Docket Number:	23-AFC-01
Project Title:	Morton Bay Geothermal Project (MBGP)
TN #:	250396
Document Title:	Morton Bay Geothermal Project Data Adequacy Response Set 1
Description:	N/A
Filer:	Jerry Salamy
Organization:	Jacobs
Submitter Role:	Applicant Consultant
Submission Date:	5/30/2023 2:00:17 PM
Docketed Date:	5/30/2023

Data Adequacy Supplement

Morton Bay Geothermal Project
(23-AFC-01)
May 30, 2023

Figure DA4.0-1a
Production Wells
Morton Bay Geothermal Project
Imperial County, California

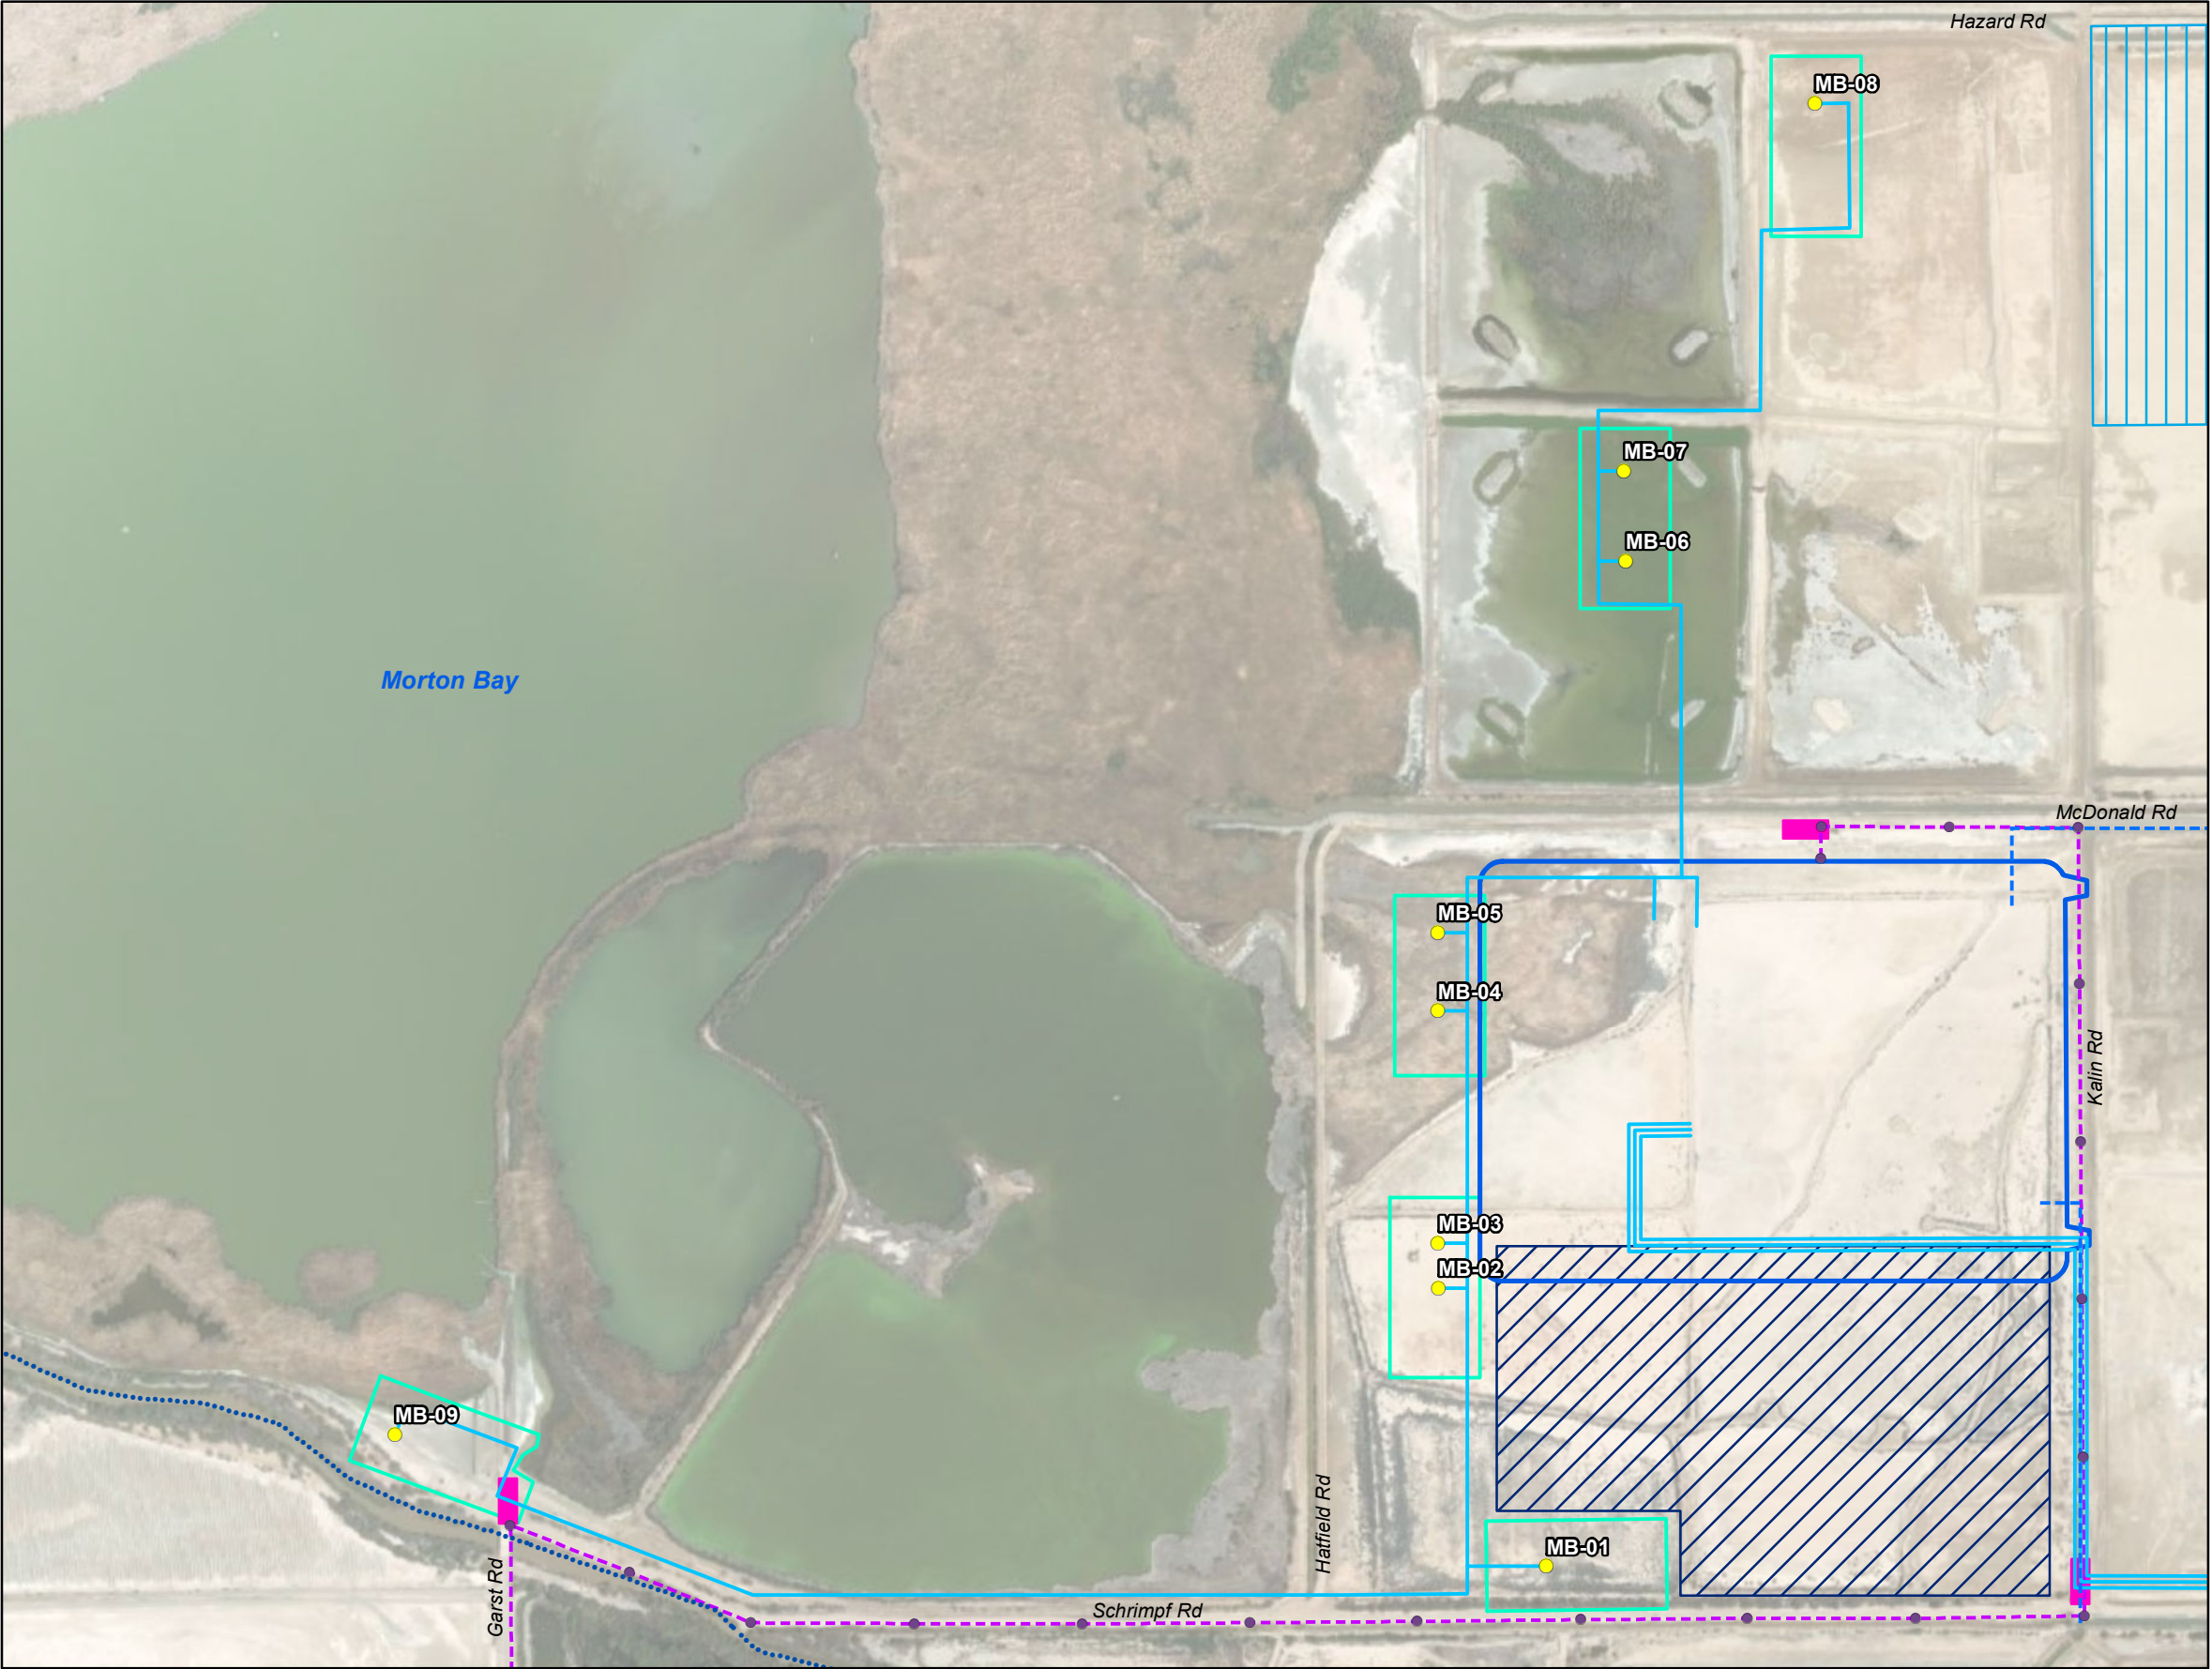
Detailed discussion with well numbers, of all wells and well pads, including production, injection, and make-up wells, along with diagrams at a suitable scale, should be included in the AFC, as part of the larger discussion of the geothermal leases and site selection, suggest 2.3.3 with discussion headings for each well type.

Response: Figure DA4.0-1a shows the six production well pads and wells MB-01 to MB-09, at a suitable scale. The well pads with wells MB-01, MB-08, and MB-09 have sufficient space for an additional well to be added.
